Background and Rezoning Process Summary

Proposed Rezoning from PUD-B, Planned Unit Development-Business, to PUD-R, Planned Unit Development-Residential for proposed Clearview Crossing of Stoneridge Residential Subdivision

Background Information Staff Comments/Recommendation
City of Springboro Planning Commission Meeting
Wednesday, January 18, 2023, 6:00 p.m.
Council Chambers, City Building, 320 West Central Avenue

Rezoning, Clearview Crossing at Stoneridge, southwest corner of East Central Avenue (SR 73) and Red Lion-Five Points Road, Clearview Crossing residential subdivision

308-343 CLEARVIEW CROSSING
EXHIBIT B
SIGHT DISTANCE AT HAVERSTRAW PLACE

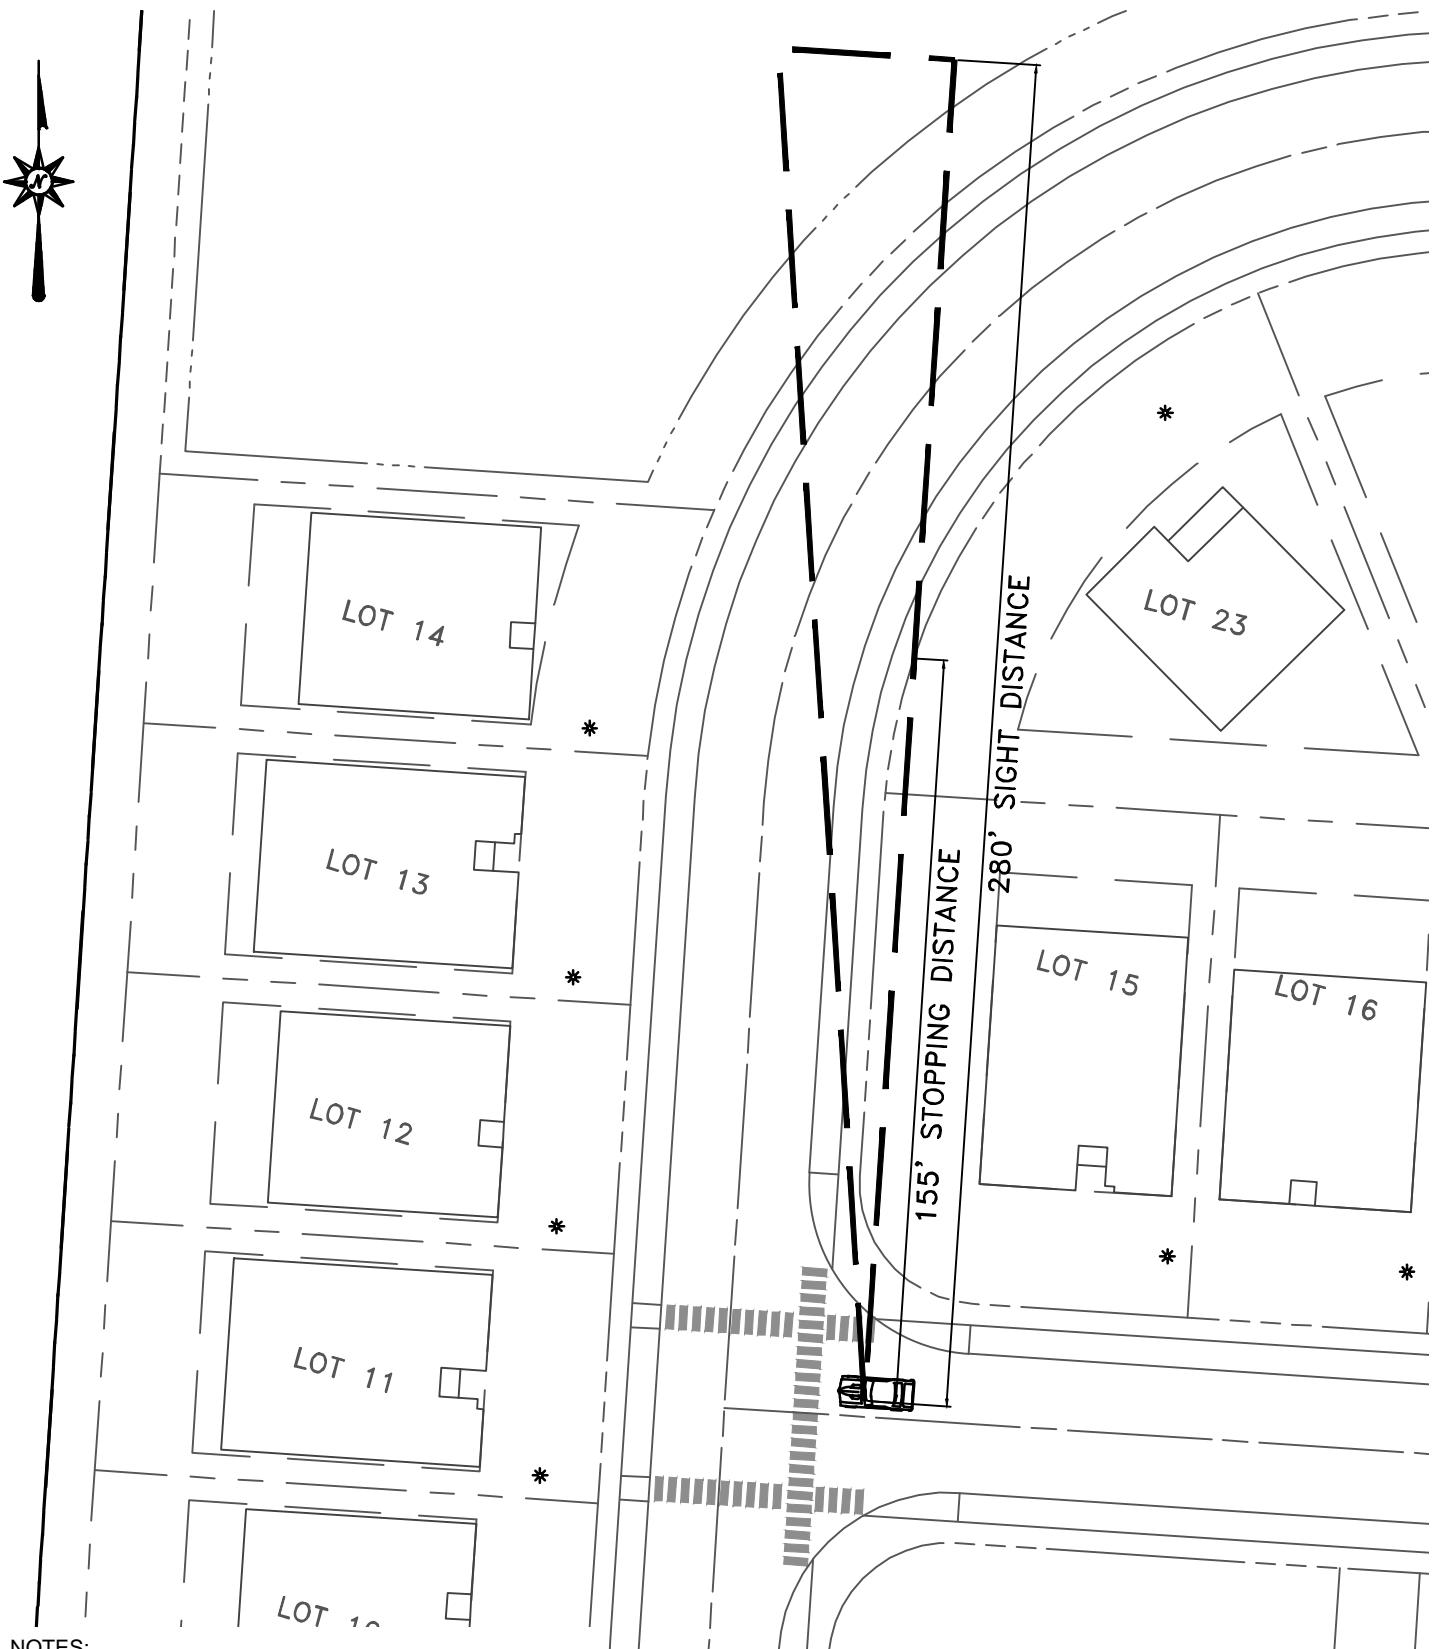
15. *Provide intersection sight distance at the west intersection with Haverstraw Place per ODOT standards. Adjust lots 15 and 23 accordingly (and setbacks) and provide sight distance easement.*

Response: West-bound vehicles will be stop controlled at the intersection to Haverstraw Place and a speed limit of 25 mph for both roads. Site distances will be about 150'. Building setbacks are shown on the Layout Plan (Refer to sheet 3 of 4). Homes would be set behind the setback line. Providing clear site lines for 150'. Right-of-way and buffer landscaping within any potential sight lines will avoid evergreen plant species. Contour lines depicted on plans reflect the existing topography of the site. Proposed contour lines, needed to confirm compliance with ODOT standard sight distance triangles, will be shown upon creation of the Grading Plan, at the final development plan submittal.

CLEARVIEW CROSSING
OF STONE RIDGE
EXHIBIT A
TYPICAL BUFFER YARD LANDSCAPE
Situate In
City of Springboro, Warren County, OH

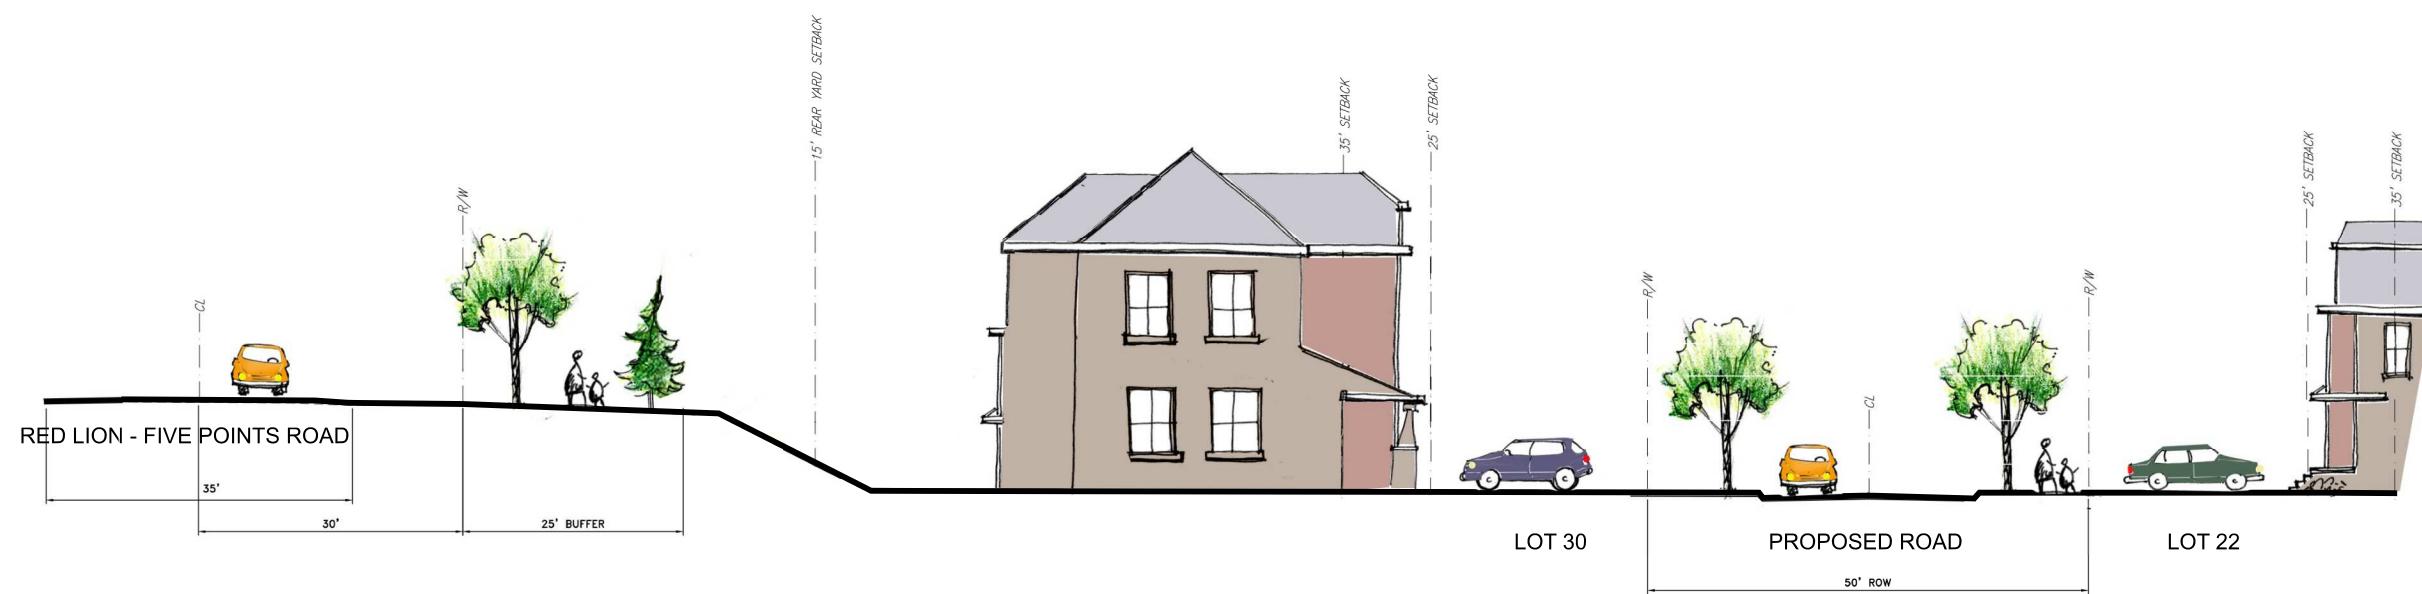
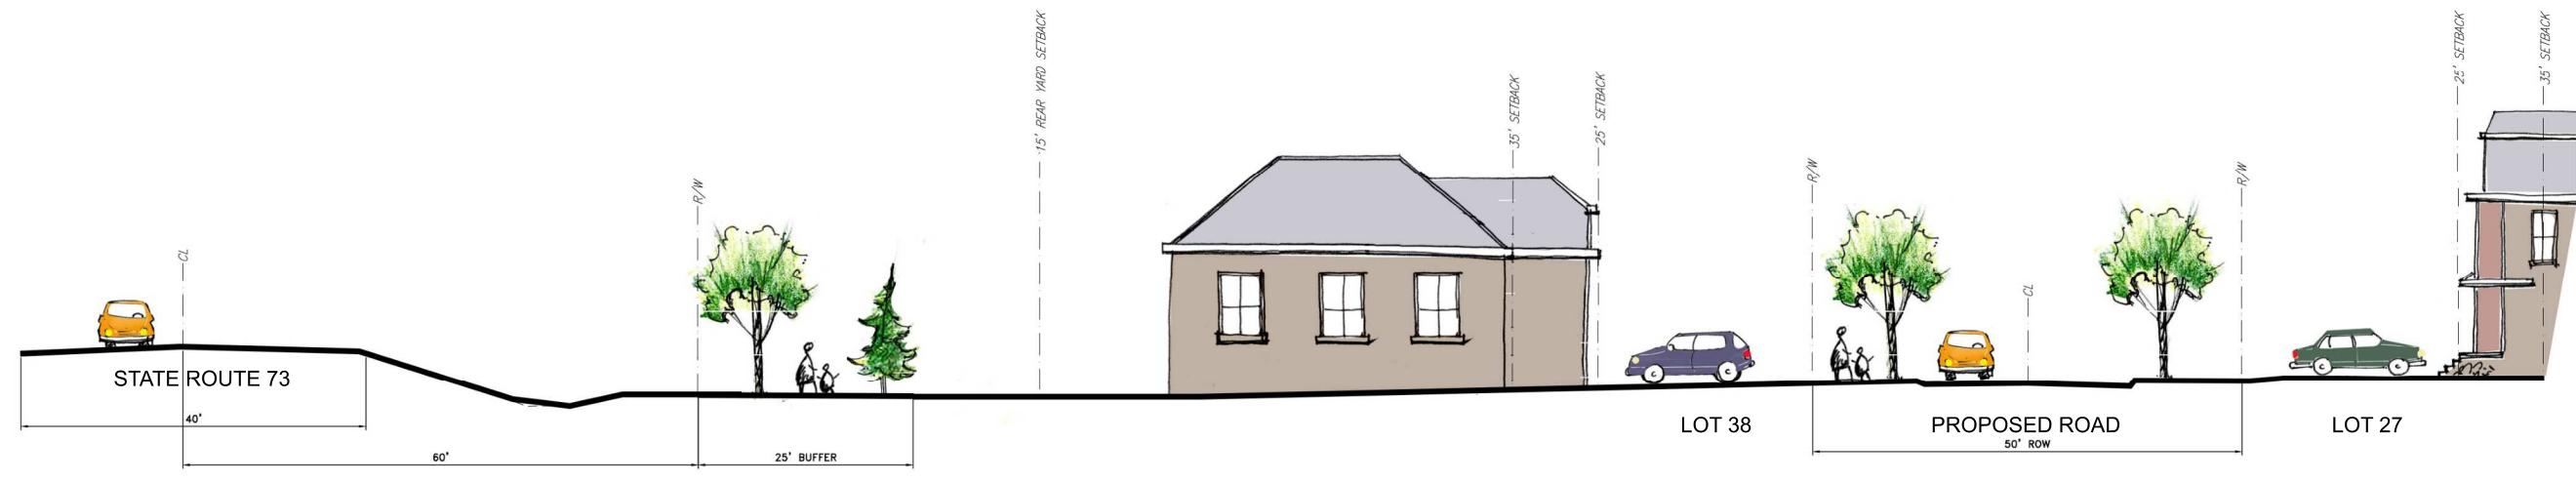
4. *Provide landscaping plan for the subdivision consistent with provisions of Chapter 1280 of Planning and Zoning Code.*

Response: A landscaping plan was provided as part of the preliminary plan submittal. Refer to sheet 4 of 4.
